Subject: Authorization to Proceed & Conditional Approval of Repair Designs, Canyon Fuel Company, LLC, Gordon Creek 2, 7 & 8 Mine, C/007/0016, Task ID #5016

Addendum to Appendix 7-1

Revised Plan for Repair of Reclamation Channel SD-6 at the Gordon Creek 2, 7, 8
Mines, Carbon County, Utah

FIGURE 1. REPAIRED RECLAMATION CHANNEL SD-6 CROSS SECTION

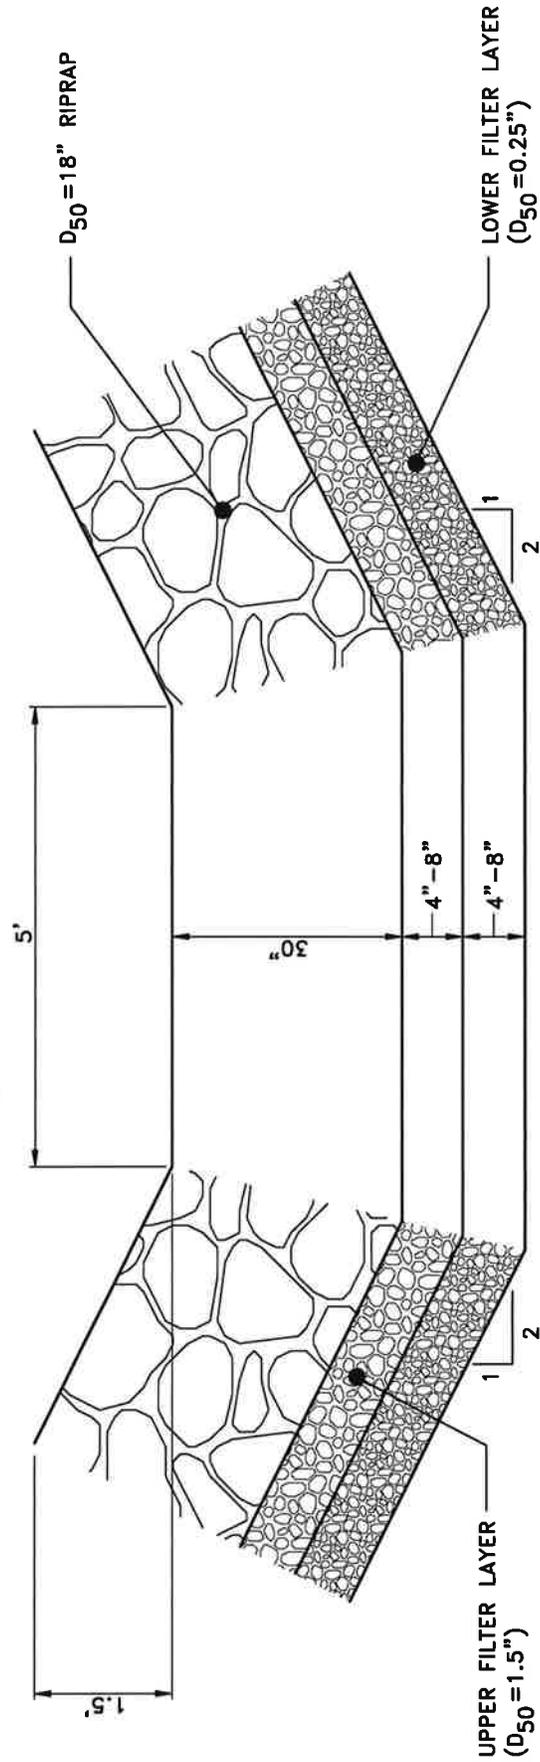
Consistent with the recommendations of Brown and Clyde (1989), each filter layer will be placed to a thickness of 4 to 8 inches. The resulting cross section of the lower portion of reclamation channel SD-6 is shown in Figure 1.

Only the lower of channel SD-6 will require repair. In accordance with the above calculations, the channel will be replaced as indicated on Figure 1. The basic plan for repair of the channel is as follows:

- Mobilize equipment and materials to the site and install sediment controls as necessary.
- Recover riprap and filter material that has accumulated at the downstream end of the channel for re-use as appropriate.
- Regrade the lower section of the damaged channel, as necessary, to fill eroded sections and achieve the required grades.
- Install the lower filter bedding ($D_{50}=0.25$ inch) to a depth of 4 to 8 inches.
- Install the lower filter bedding ($D_{50}=1.5$ inches) to a depth of 4 to 8 inches.
- Install $D_{50} = 18$ inch riprap to a depth of 30 inches.
- Revegetate all areas disturbed by this project.
